1A & 1C Eynsham Drive, Abbey Wood

Design & Access Statement - Addendum R1

Date: 14 September 2018

Revised ground floor plan illustrating additional active frontages at ground floor

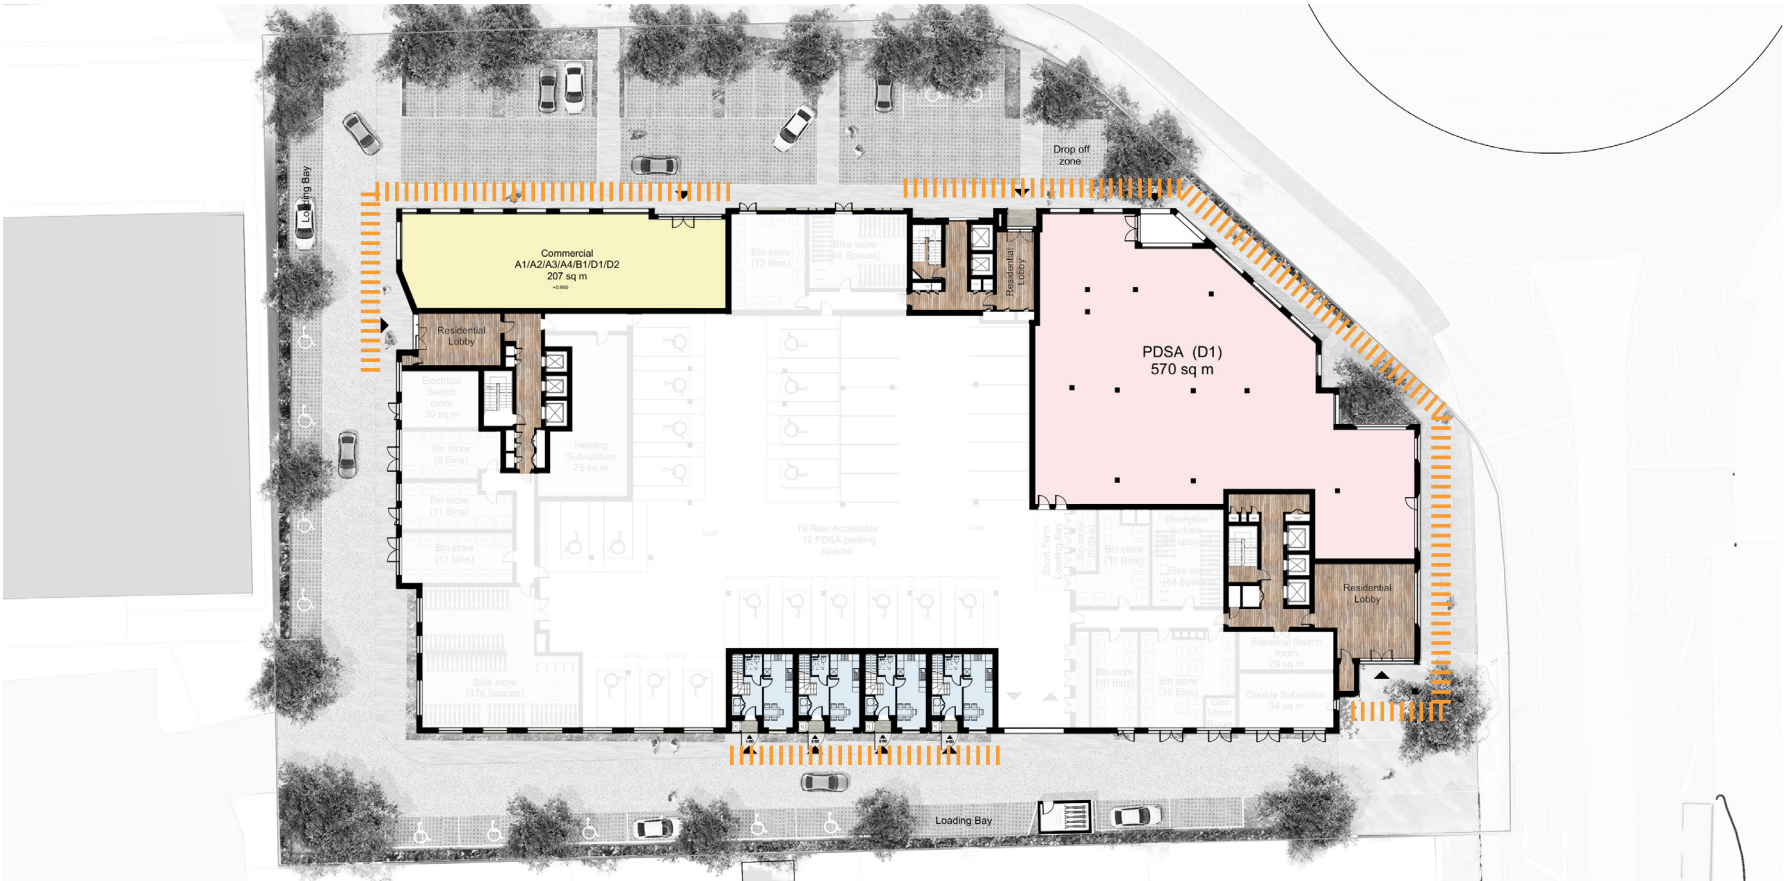
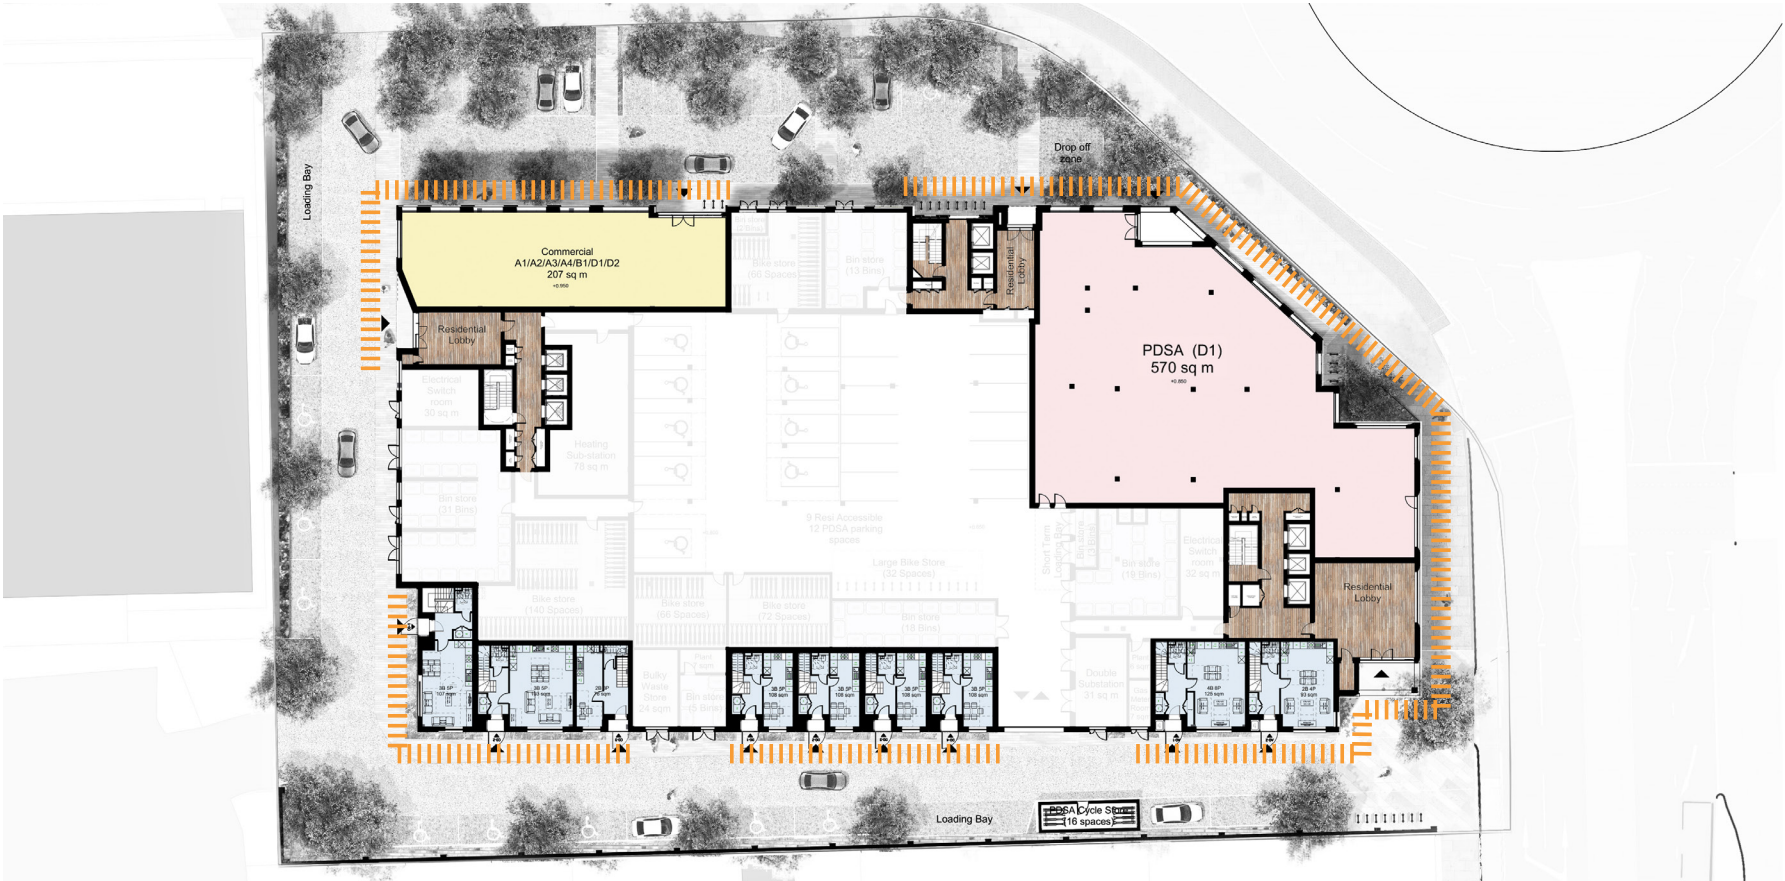
The key driver behind the amendments to the scheme is to increase the active frontage along the southern side of the building.

The introduction of duplex units results in increased activity and public surveillance of the street. The ground floor of these units benefit from a tall floor to ceiling height and recessed entry points directly off the street.

The images to the right show the originally proposed scheme and the updated proposals to provide a direct comparison.

Proposed ground floor plan

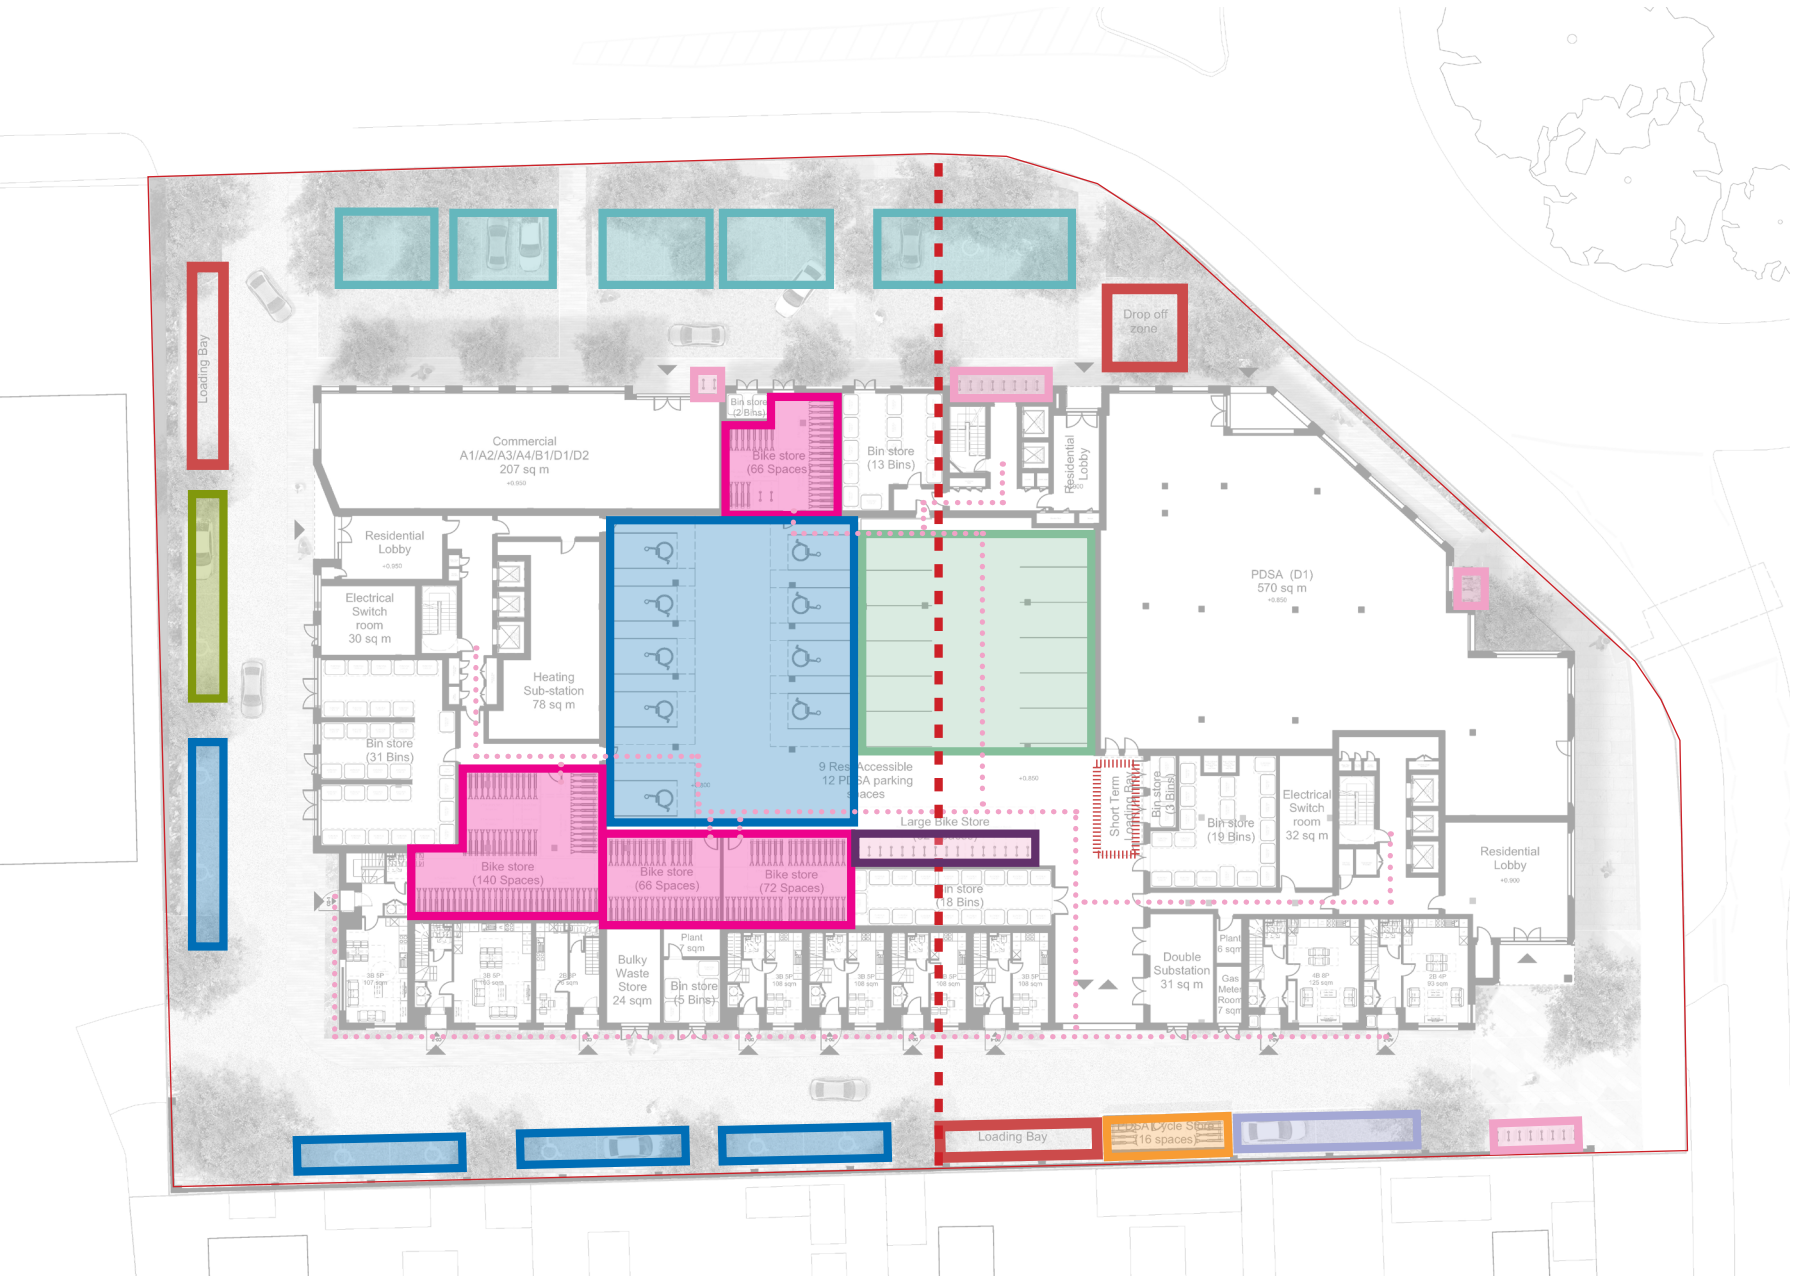
The cycle parking arrangements have been updated to meet the increased requirements of the Draft London Plan 2017. A total of 550 cycle spaces are provided across the entire scheme

The development will provide secure residential cycle parking facilities at ground floor and basement level. Cycle storage is provided close to the core of the buildings to enable easy access to/from residential units. An alternative route through the car park is provided to avoid bringing bikes through residential lobbies.

Cycle spaces have also been provided for users with larger cycles whilst the remaining spaces are provided as a double stacker system. Cycle stands for short term visitors to the residential units are also provided in easily accessible locations at ground floor level within the public realm.

Proposed area of new boundary wall

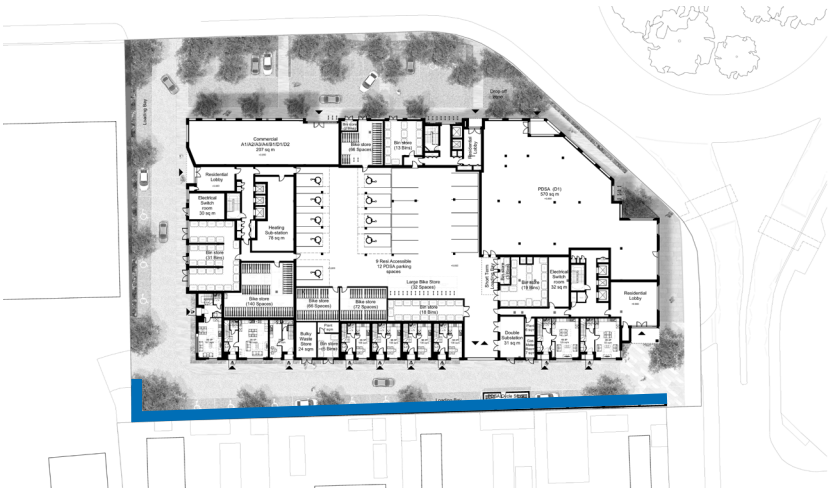
The existing boundary fence is of low quality and in poor condition and should be replaced as part of the proposal. This will improve outlook, privacy and security for all parties. The existing fence is approximately 2 meters high.

We propose a new wall of masonry construction 2.5 meters high, to ensure no overlooking from first floor level, with a trellis detail above, to provide further privacy but also allow light to penetrate through. This will provide a robust boundary edge and reduce overlooking whilst still maximising daylight to windows on the ground floor on both sides without affecting the existing quality of Thistlebrook Estate. Planting is proposed along the wall edge to encourage climbers to green this wall and embed it into the context.

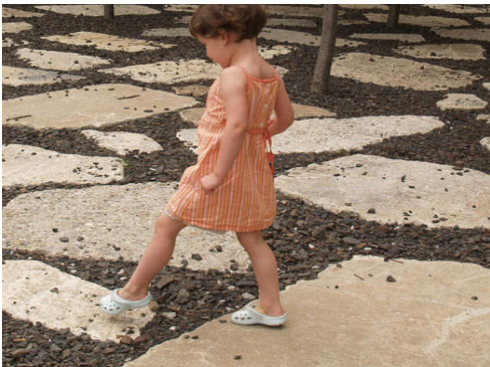
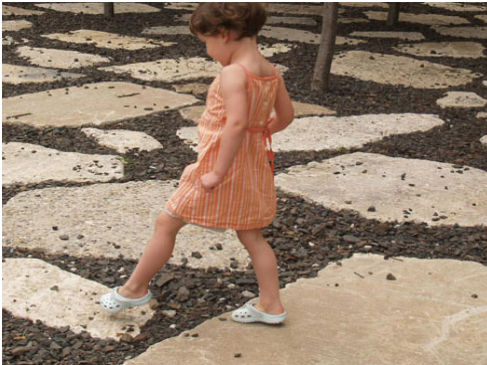
- Updated Hard material strategy :
- Replace grasscrete with resin bound gravel
